# TECHNICAL BULLETIN

[Issue No.] FA-A-0139

[Title] Addition of the moving averaging process function to the Q64TCTTN, Q64TCRTN, Q64TCTTBWN, Q64TCRTBWN, L60TCTT4, L60TCRT4, L60TCTT4BW, and L60TCRT4BW

[Date of Issue] August 2012

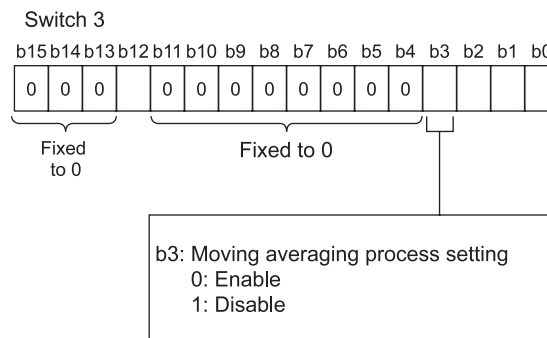
This function is used to set the moving averaging process to a temperature process value (PV). With this function, the fluctuation of temperature process values (PV) can be reduced in electrically noisy environments or environments where temperature process values (PV) fluctuate greatly. The number of moving averaging can be set in the range of 2 to 10 times. The moving averaging process is enabled (number of moving averaging: 2 times) as the default action for the module. By disabling the moving averaging process, the response to the change of temperature process values (PV) can be hastened.

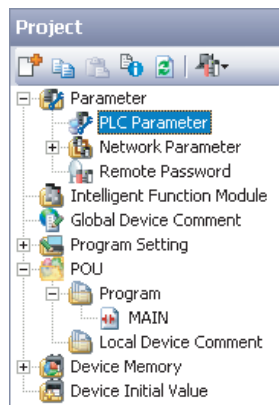
The intelligent function module switch setting for the moving averaging process is shown below.

Enable (0) is set as a default value.
